Ref: FCC Class II Permissive change for FCC ID: 2AYG7- JPCD1020211

This is to request a Class II Permissive change for FCC ID: 2AYG7- JPCD1020211 granted on 1/29/2021 (date).

Changes between PCB Q107_MB_V1.1 and PCB RC-US717TC

1. PCB Top and Bottom view

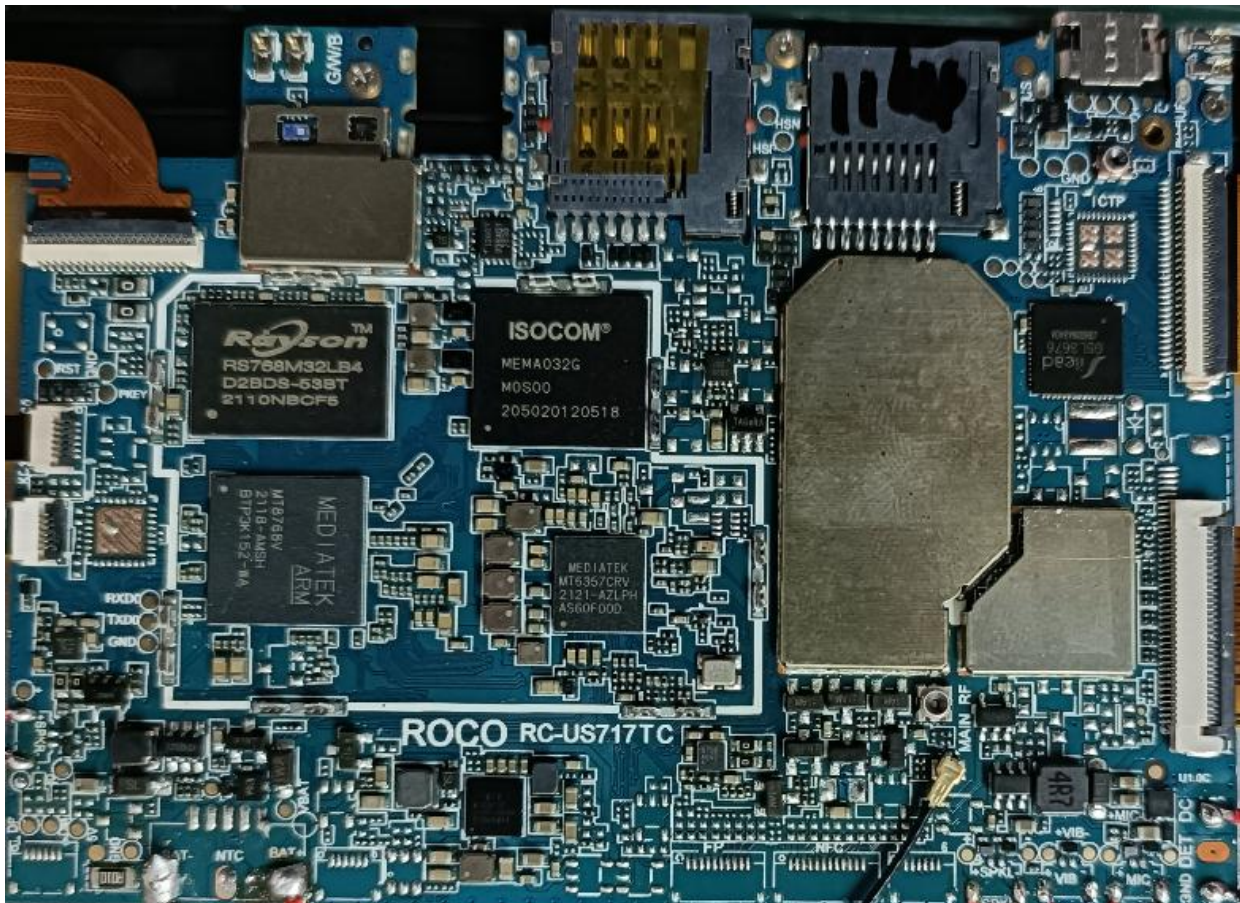
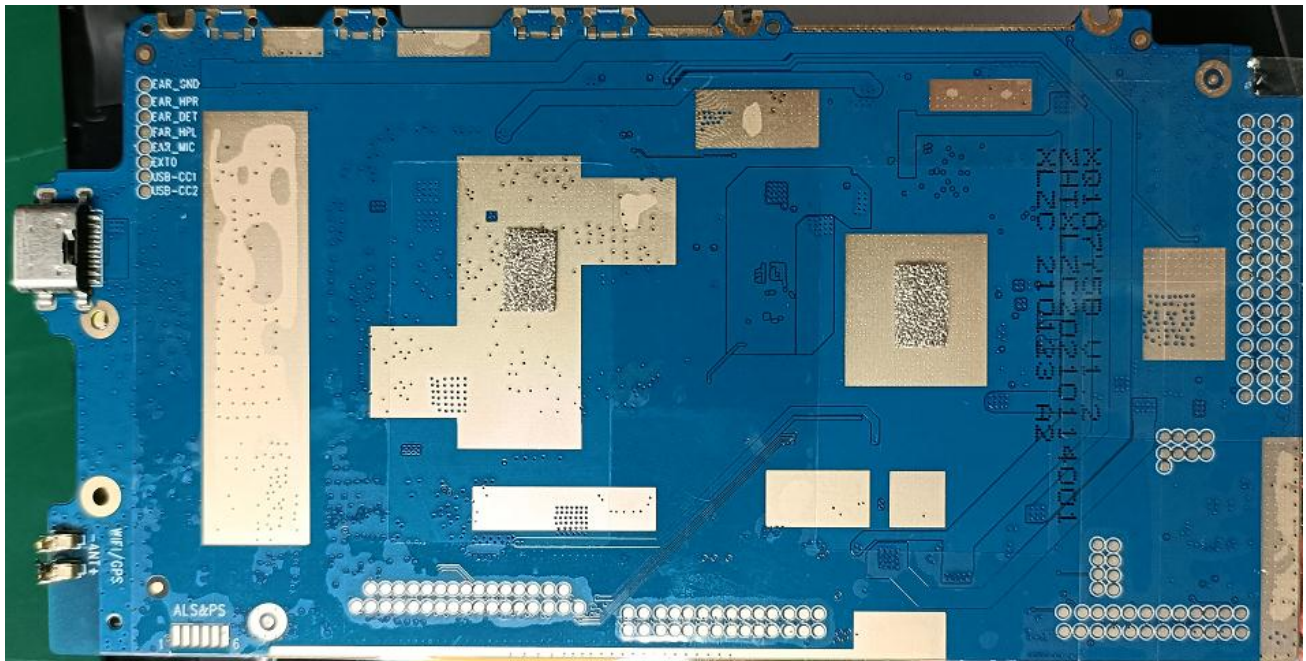
1. The SIM card slot from 2 slots become 1 slot.
2. The memory DDR ,Storage,earphone socket ,the camera is different.
3. Board shape is different, configuration is the same.
4. The original product model is JPCD1020211, now it is added model to JayPad_2_0, M10, P30, L10, M8, L8, K7, P7, M7;
5. The original manufacturer: Shenzhen Great Asia Electronic Co., Ltd. now it is changed to Benton Technology Co., Ltd
6. Original Manufacturer address: 5F, Block B, Rui Xiang Fa Industry Building, Shang Xue Technology Park, Long Gang District, Shenzhen, China, now it is changed to East Block, Building#1 Weixinda Industrial Park, No.4 Fuye Road, Wuhe Avenue, Longhua District, Shenzhen, China.
